RED SKY APARTMENTS
10140 S CENTENNIAL PKWY
SANDY, UTAH 84094

SITE PLAN REVIEW UPDATE

PROJECT: RED SKY APARTMENTS

Application No. SPR12062022-006452

SHEET TITLE:
EXTERIOR ELEVATIONS

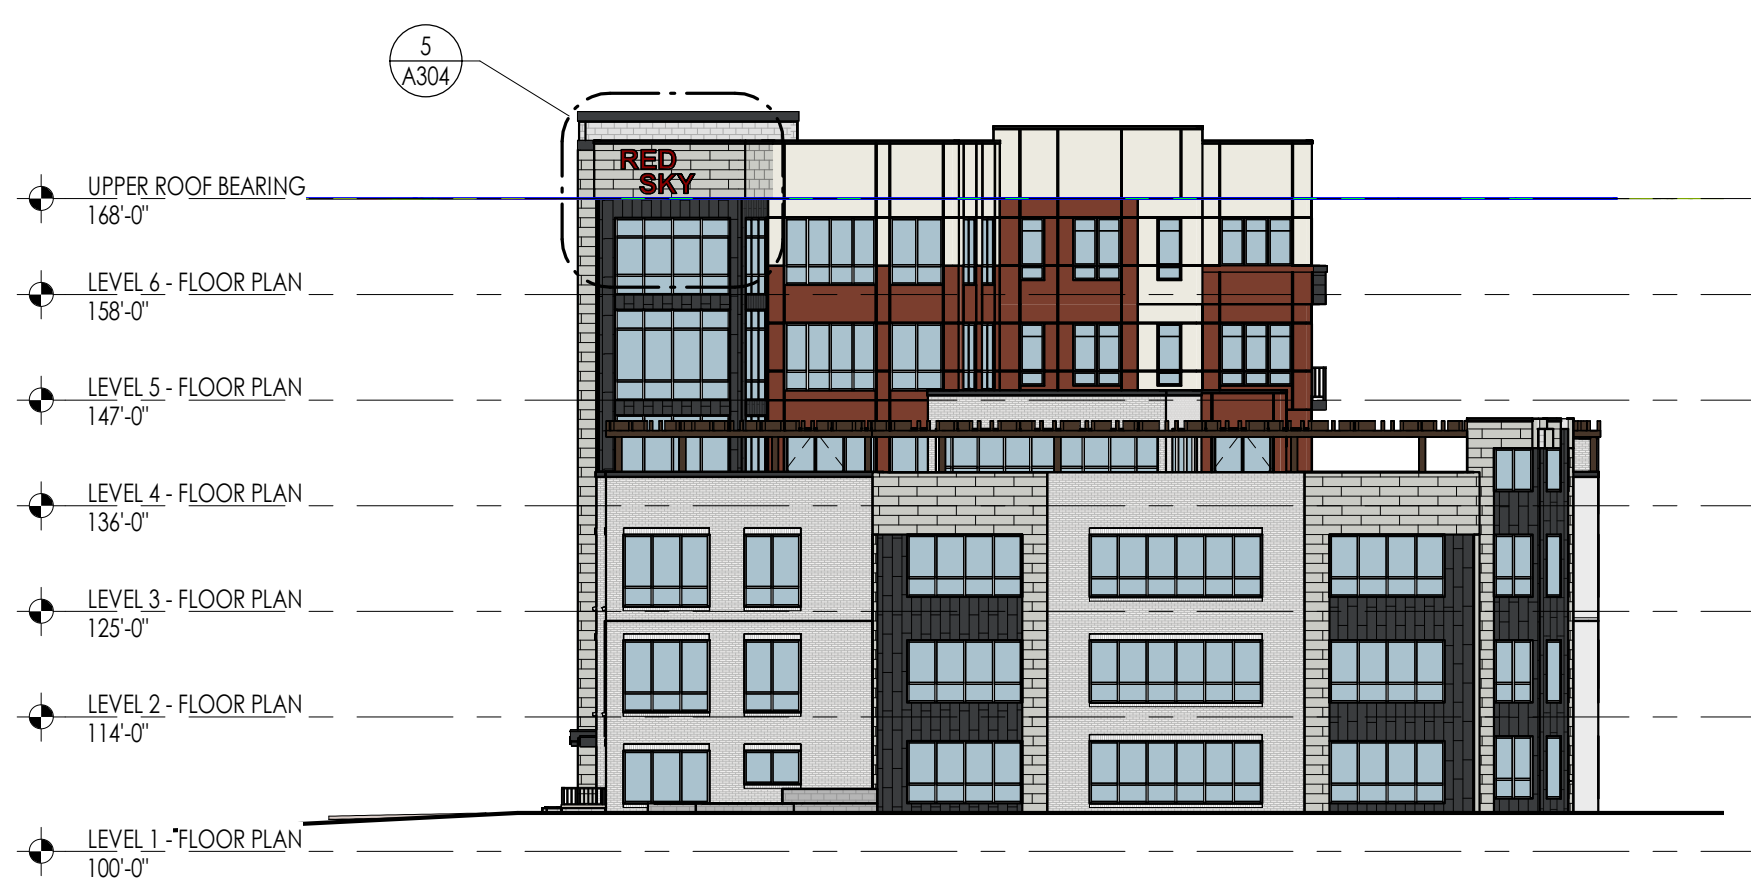
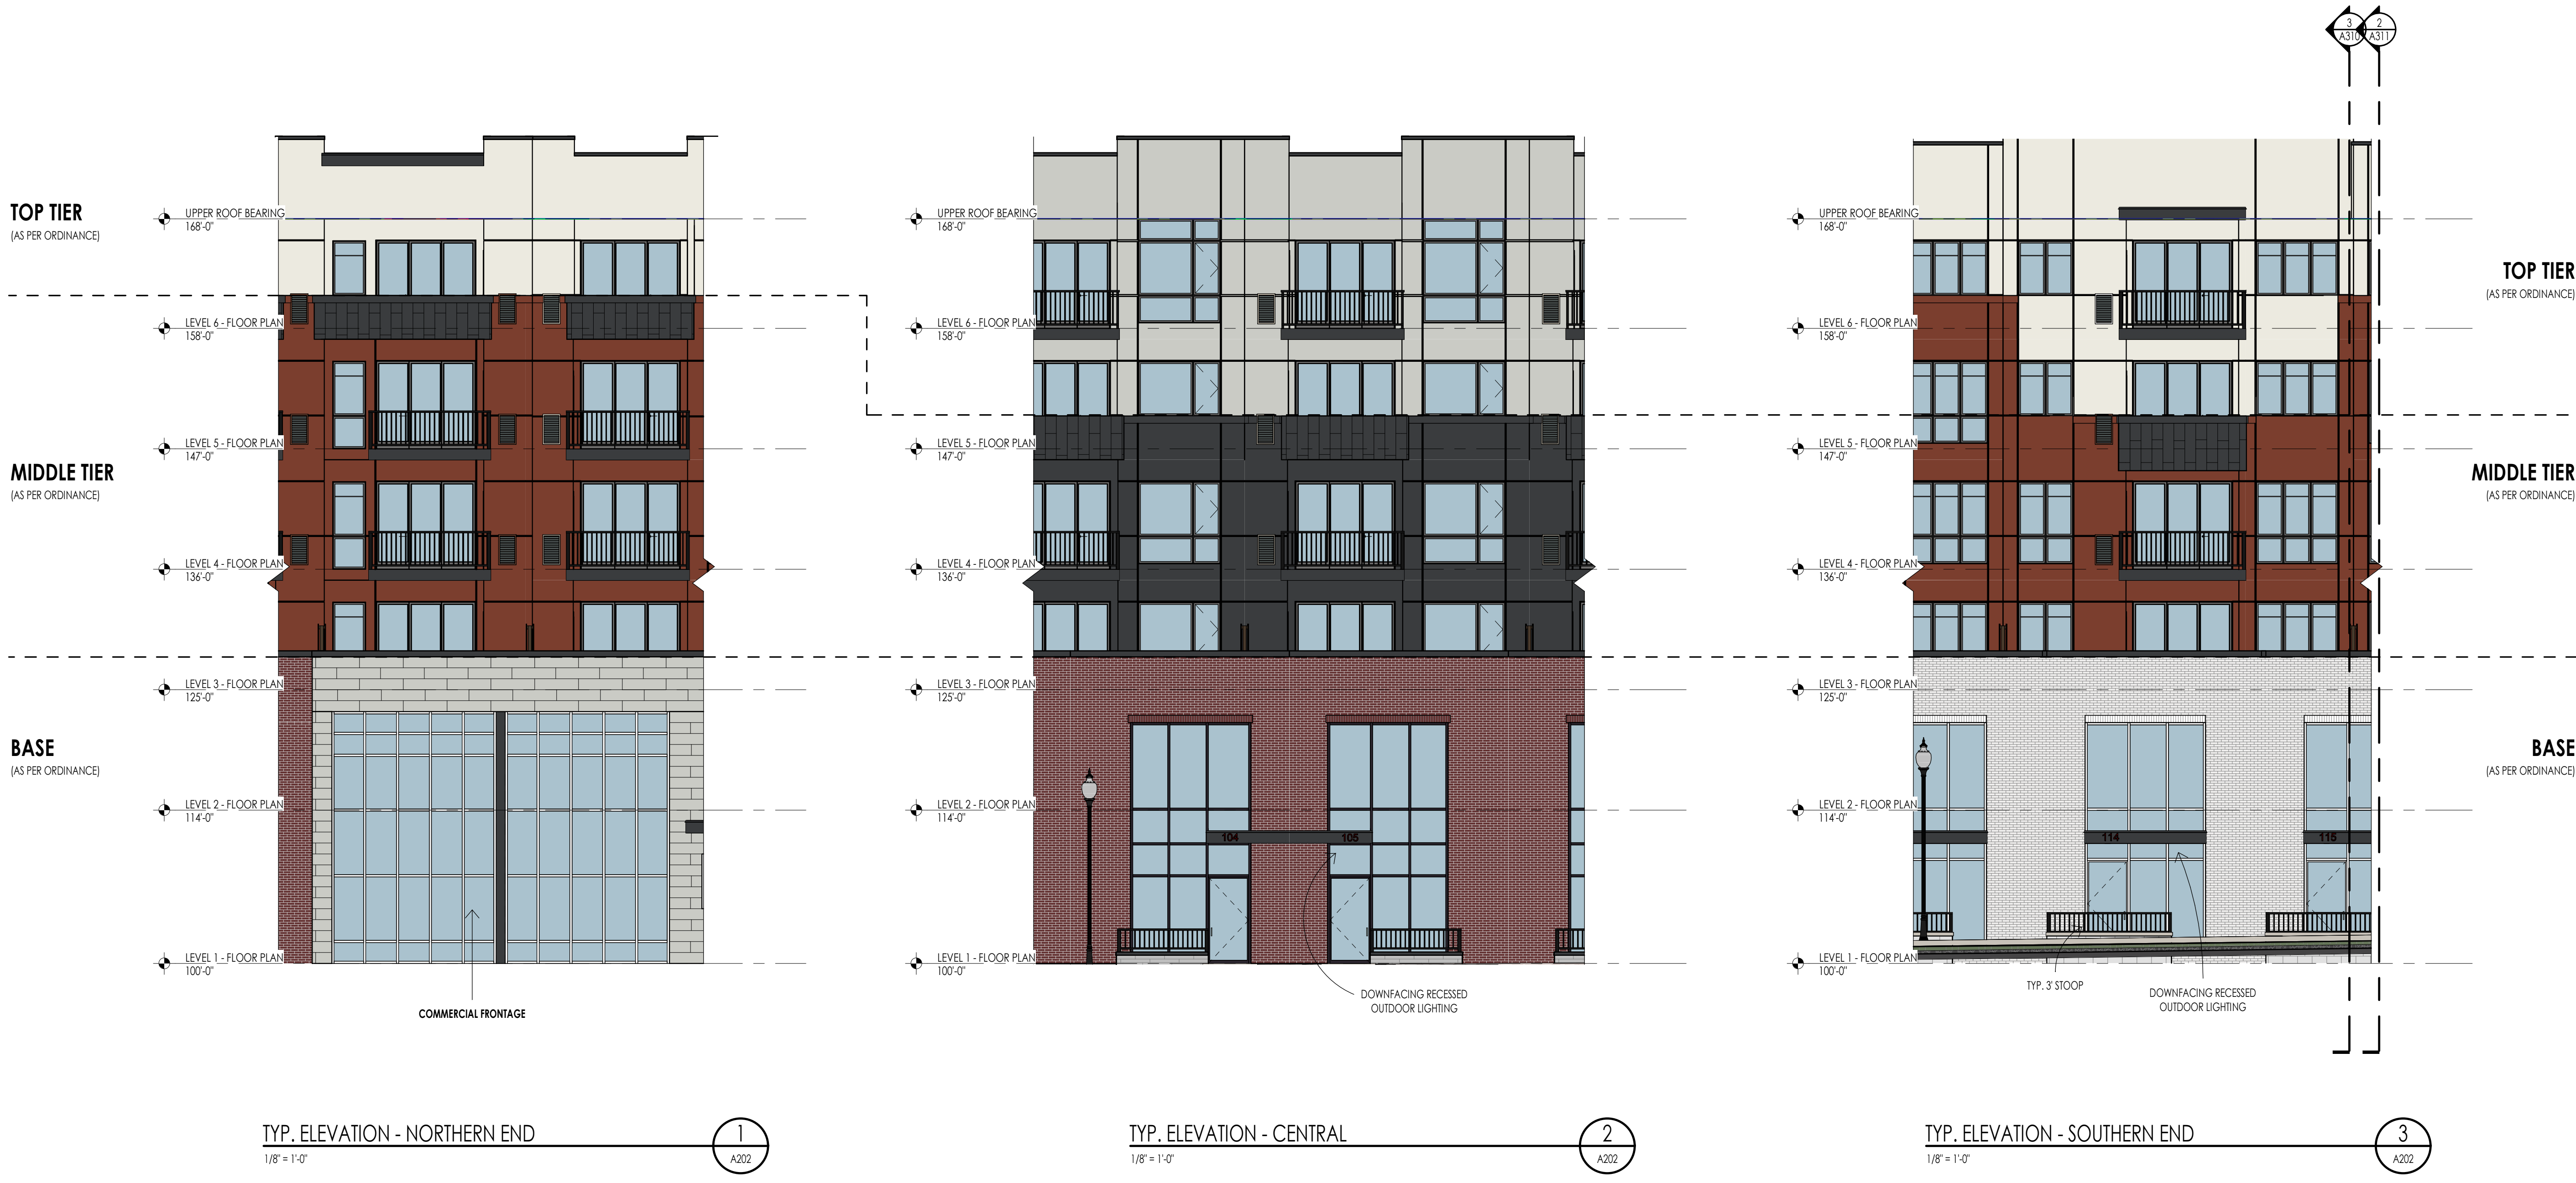
Middle and top: Middle and top stories shall have between 40% and 80% glass window treatments for <u>all facades</u>	<p><i>City Comment: What about South and East???</i></p> <p>We will need to seek an exception. The middle and top of the building are residential units and each unit has 8'-0" x 9'-0" triple sliding doors and large windows. The amount of glazing fills the design of the building well.</p> <ul style="list-style-type: none"> - East: 37% - North: 34% - South: 34% - West: 40% <p>See A301 / Fenestration Requirements</p>
<u>Entry Requirements</u>	
Ground floor units along street frontages shall include a primary entrance from the street	Proposed design complies. See A301 – A302
